## Access Compliance Report Public Rights-of-Way (Curb Ramps)

Intersection ID: 10031405 Main Street: MCALPINE\_PARK\_DR Cross Street: N/A Location: SW

ADA ID: 1382C7CDDE44 Ramp Type: BlendTrans2 Initial Pass/Fail: Fail Overall Compliance: No Severity Score: 21.25

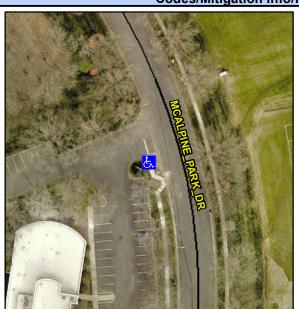
CURB LIP 0.5

Not Found, R304.5.1, R304.5.3

Remove & Replace Curb Ramp With Two New Directional Ramps or Equivalent.
